MFN 06-407
Supplement 13

Subject: Revised Response to Portion of NRC RAI Letter No. 166 Related to ESBWR Design Certification Application - DCD Tier 2 Section 3.8 – Seismic Category I Structures; RAI Number 3.8-94, Supplement 3

Revised Response to Portion of NRC RAI Letter No. 166

RAI Number 3.8-94 S03 (Revision 1)

Figure 3.8-94(15) FRS (Compared with the DAC3N) – FPE Basemat X

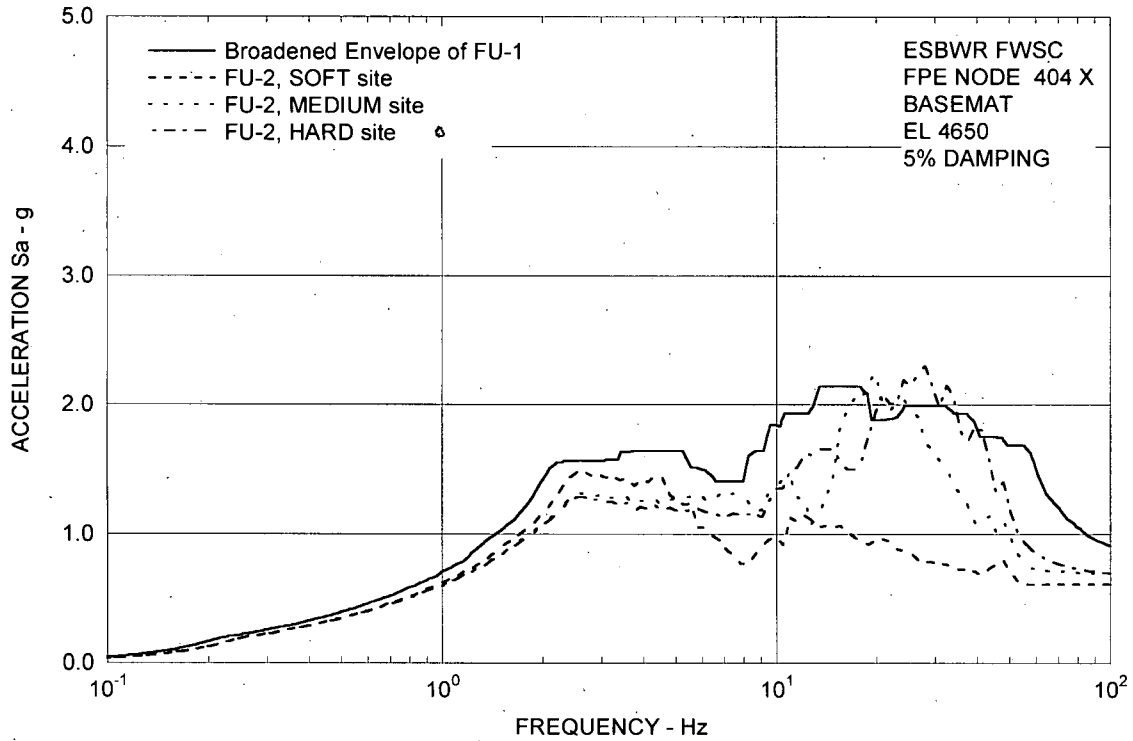
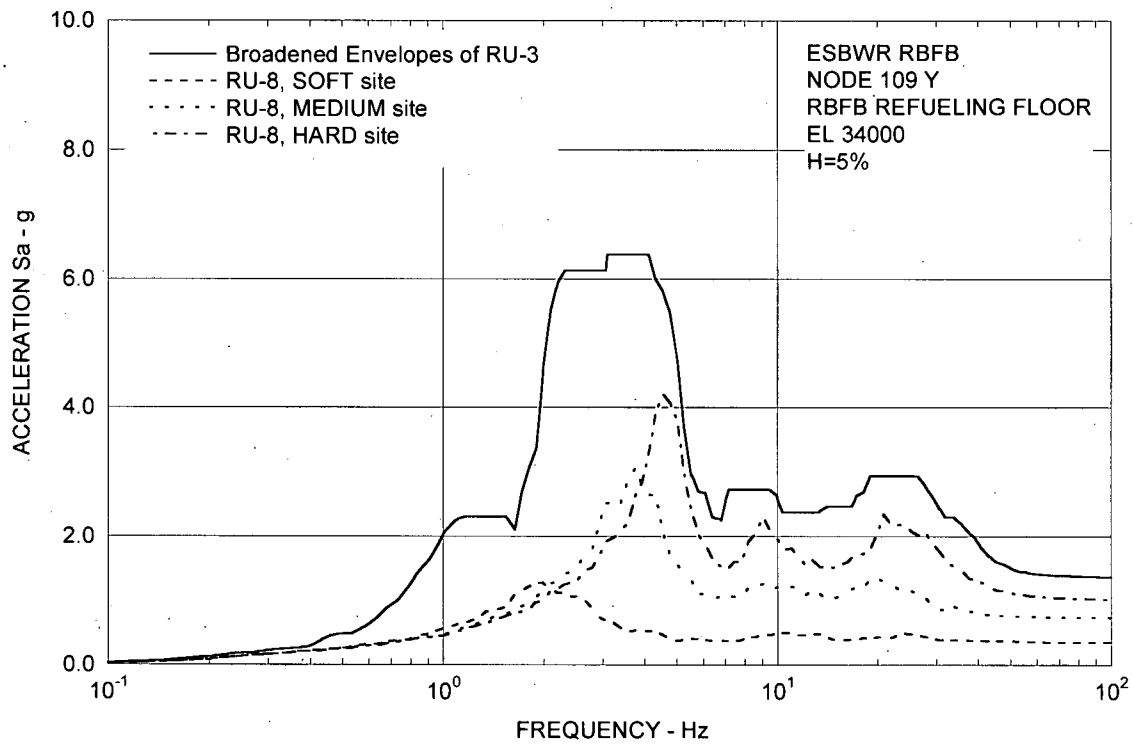
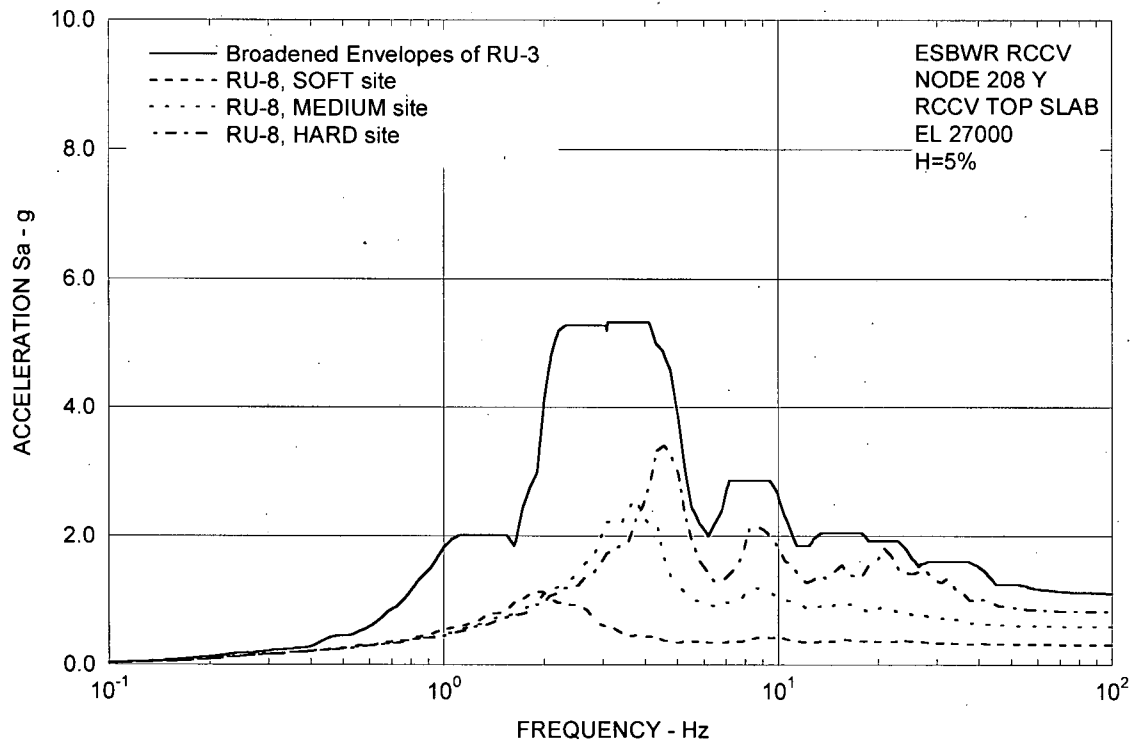
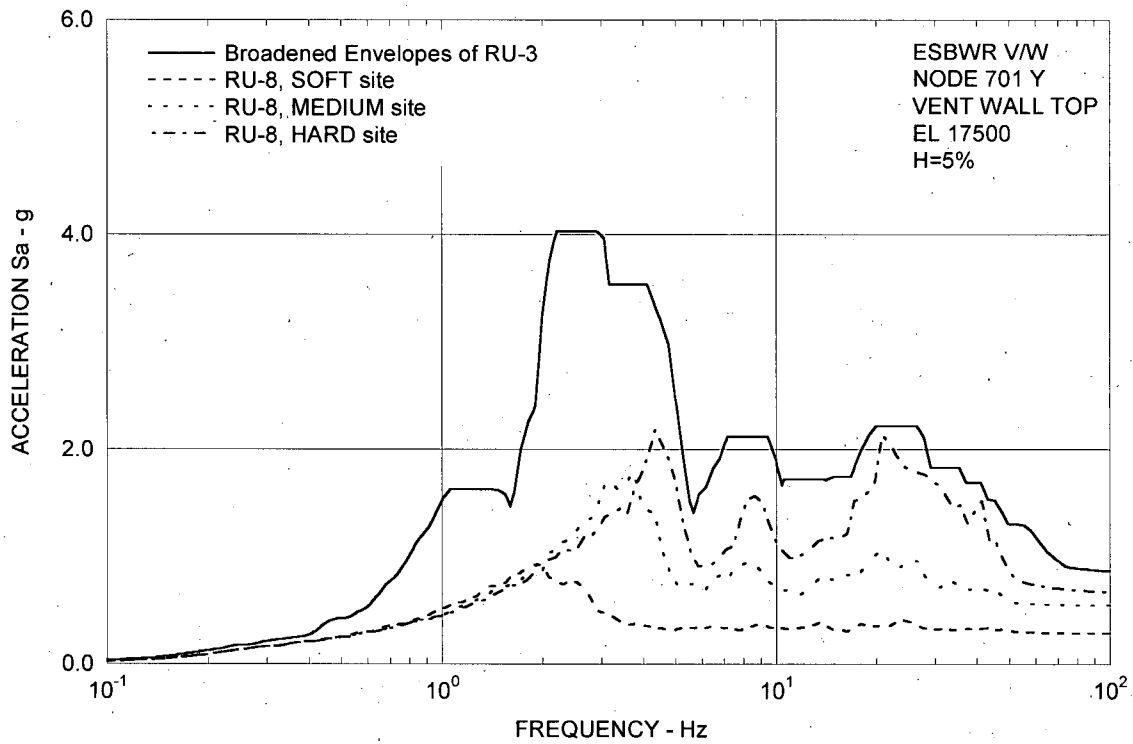
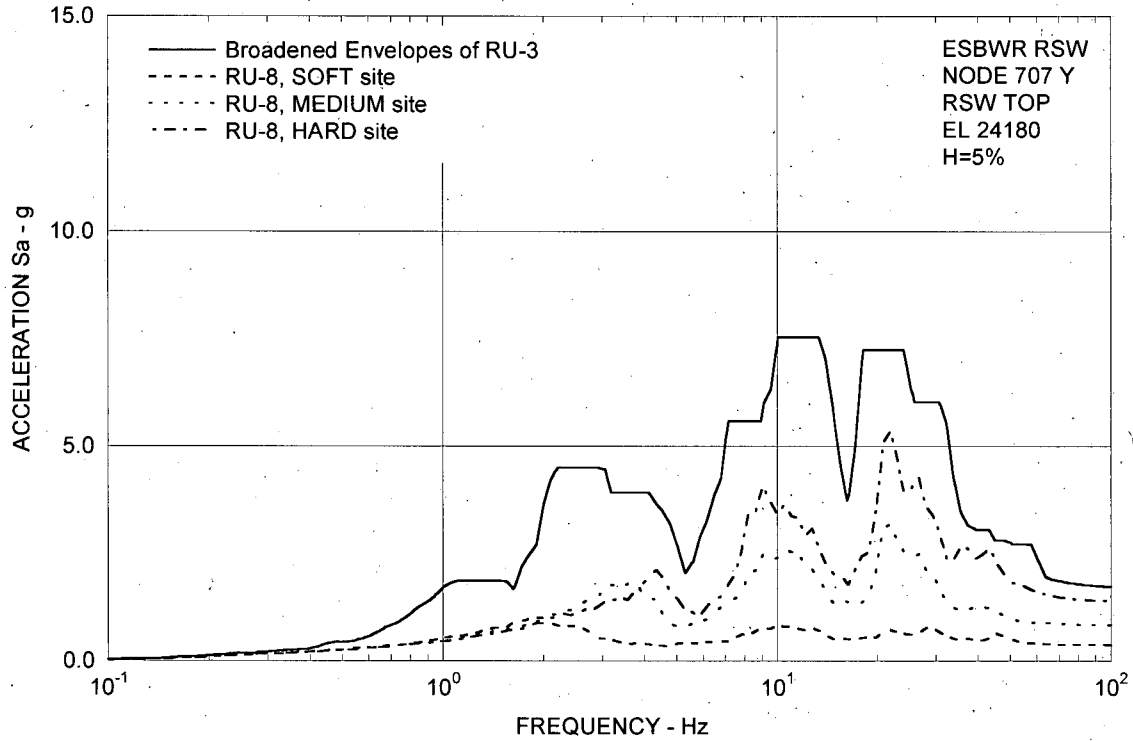
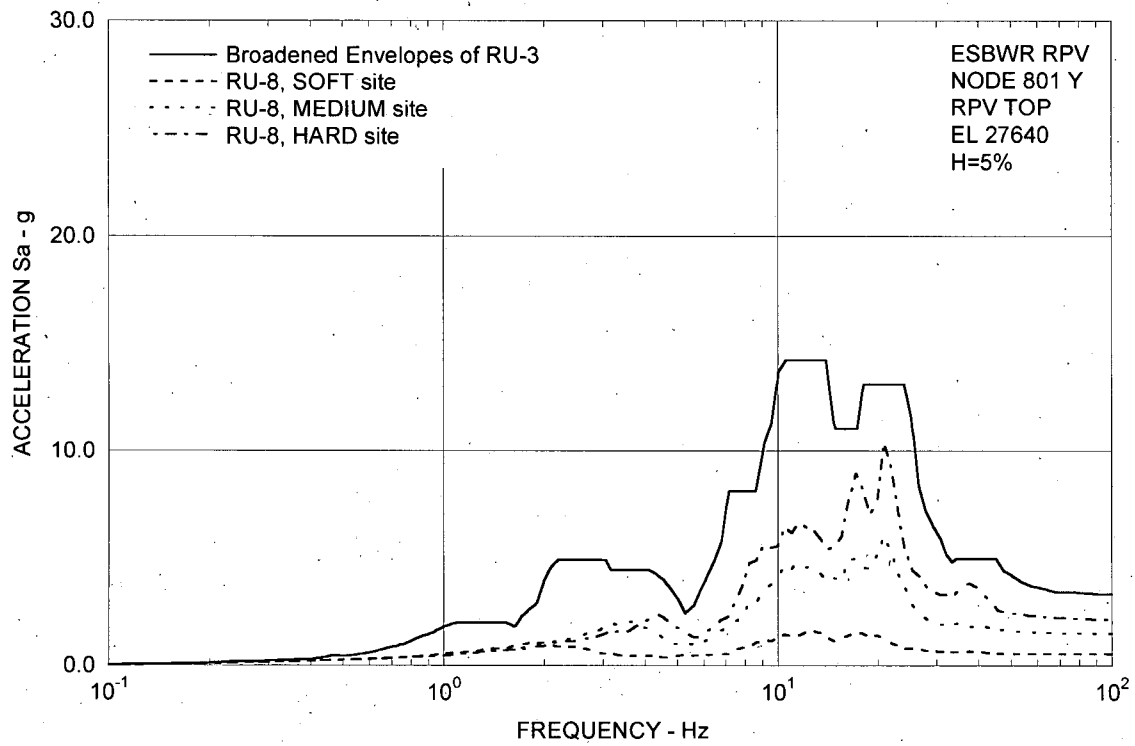
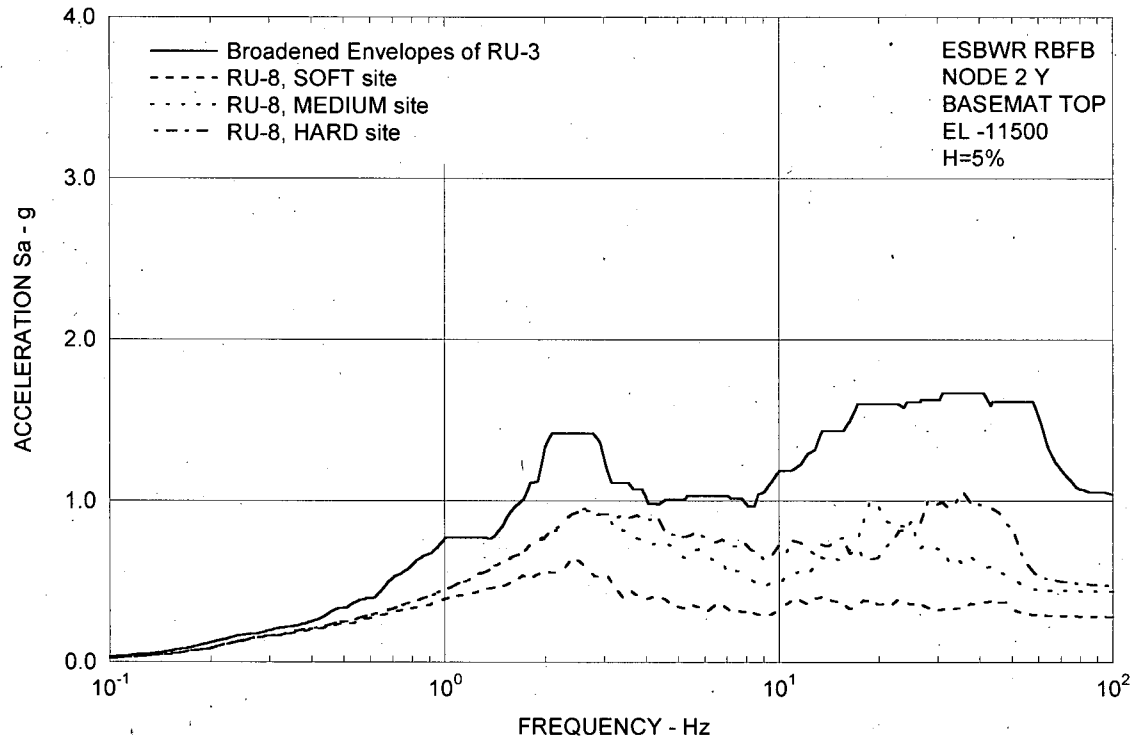
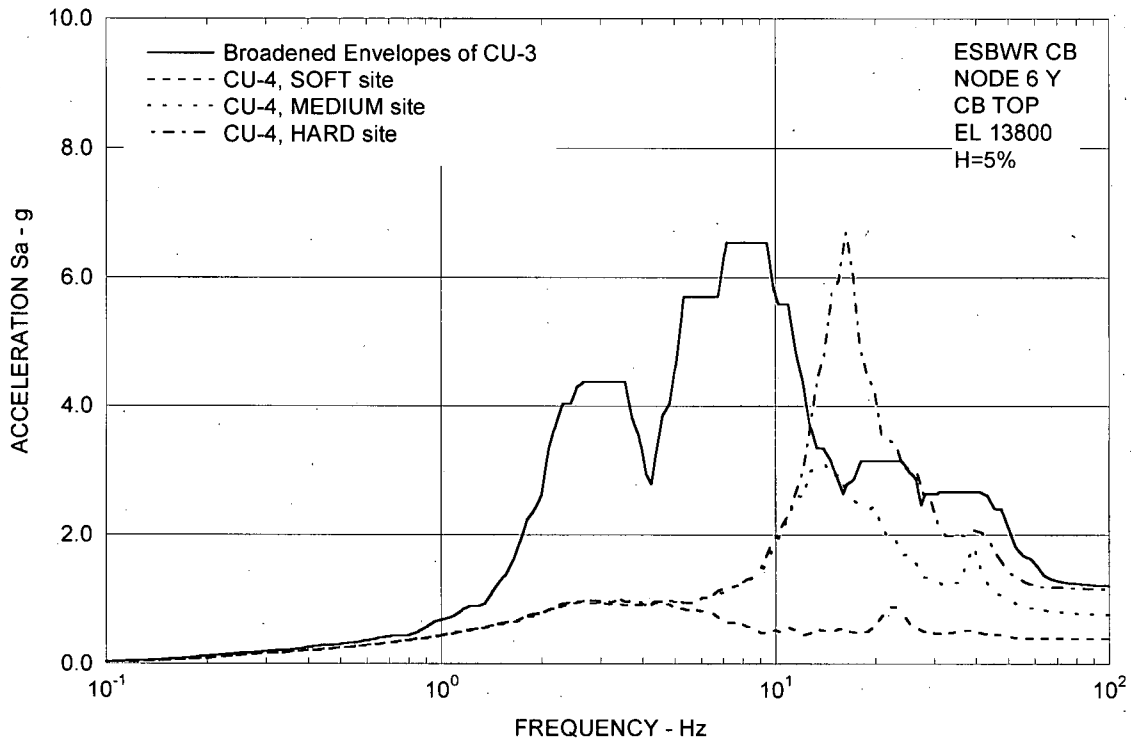
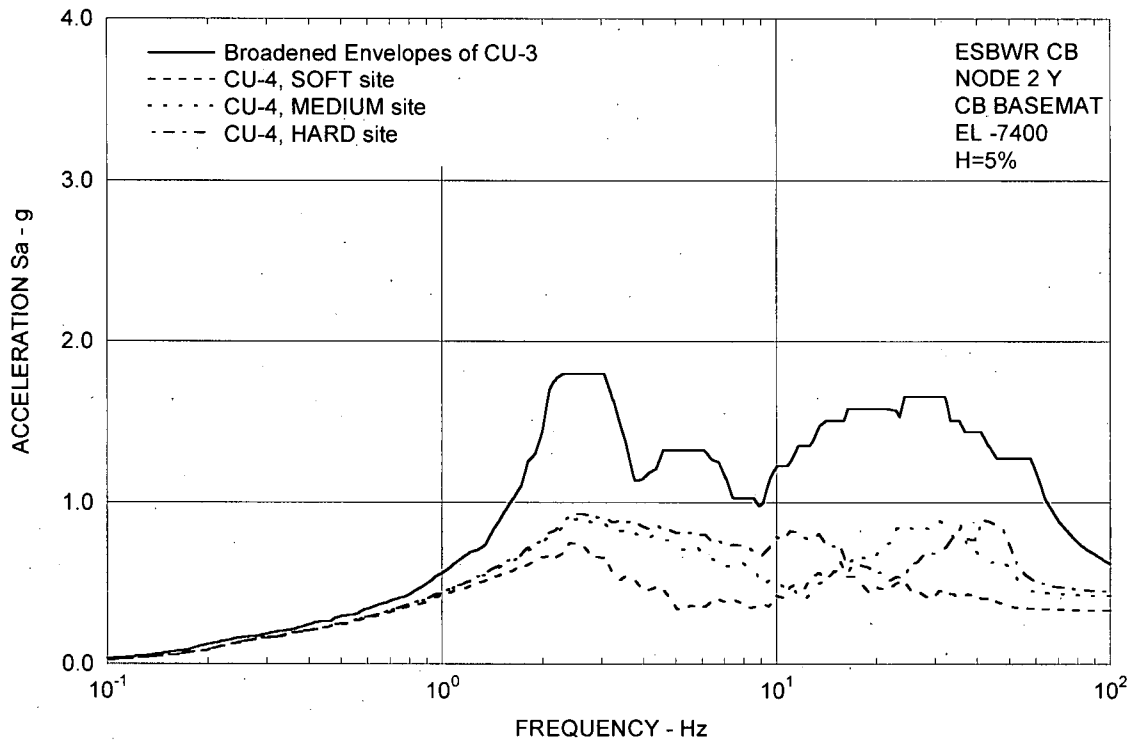
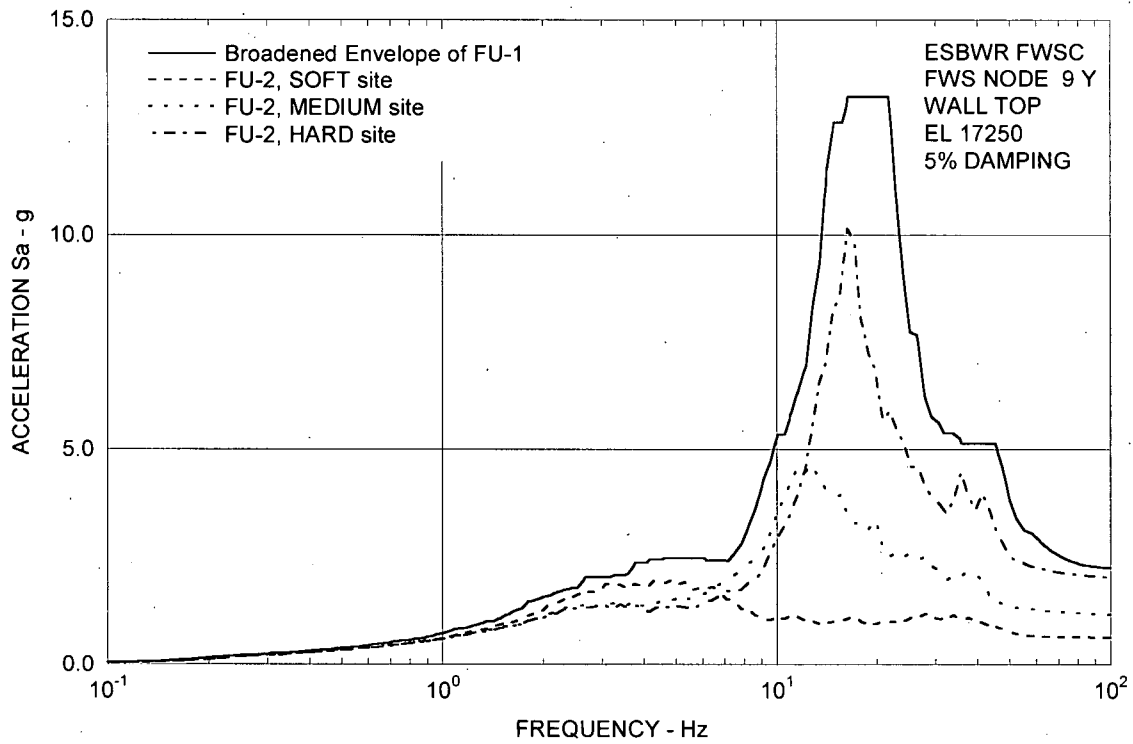
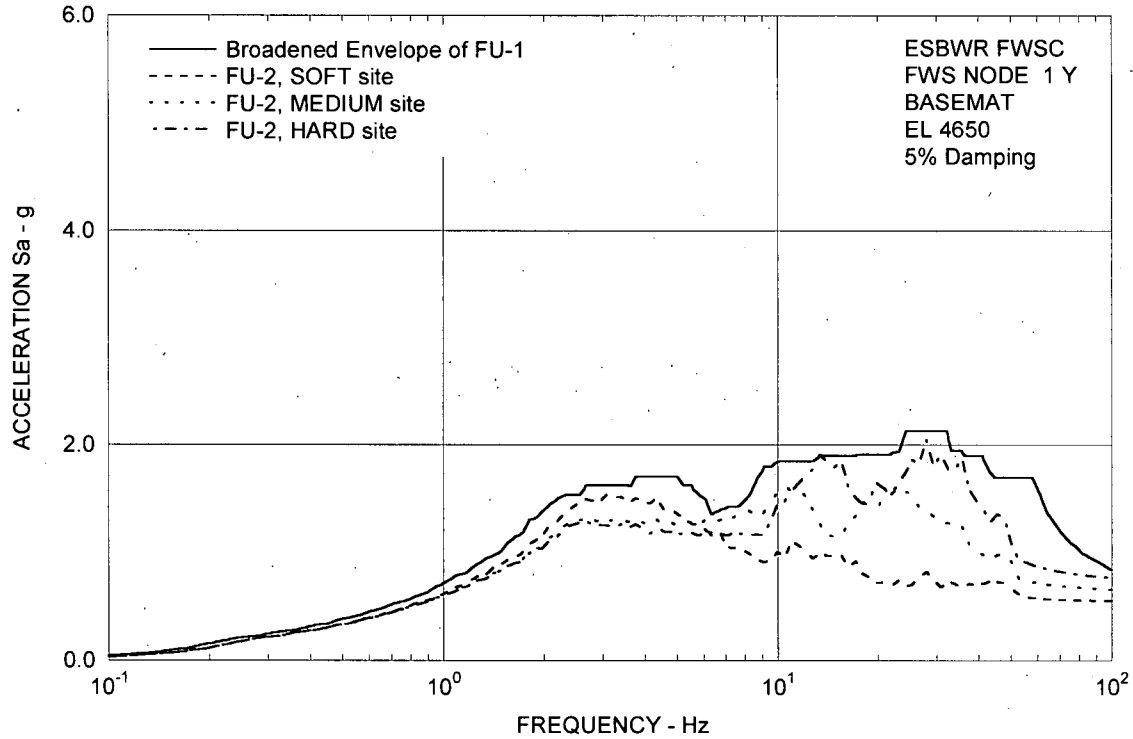
Comparisons of the response spectra are shown in Figures 3.8-94(4) through 3.8-94(15), Figures 3.8-94(16) through 3.8-94(27), and Figures 3.8-94(28) through 3.8-94(39), respectively for the X direction, Y direction, and Z direction. These comparisons will be added in DCD Revision 6 as DCD Tier 2 Figures 3A.8.7-1a through 3A.8.7-3l.

As for the RB/FB, it is found from the results that the responses for the SASSI2000 uniform cases are bounded by the broadened envelope responses of the DAC3N cases in the whole frequency range. The responses of the RU-8 uniform hard site at the vent wall top (X direction per Figure 3.8-94(6)) and the refueling floor (Z direction per (Figure 3.8-94(28)) at around 20 Hz are slightly higher around 20 Hz but the exceedance is negligibly small.

On the other hand, the response spectra of a portion of the CB above ground and the FPE in the FWSC exceeded greater than 10% at the broadened envelope responses of the DAC3N cases in the higher frequency range.

Thus, the SASSI2000 uniform site results of the CB and the FWSC are included where appropriate to obtain the enveloping design spectra. DCD Tier 2 Figures 3A.9-1g, 3A.9-1l, 3A.9-2g and 3A.9-3g will be revised in Revision 6 accordingly.
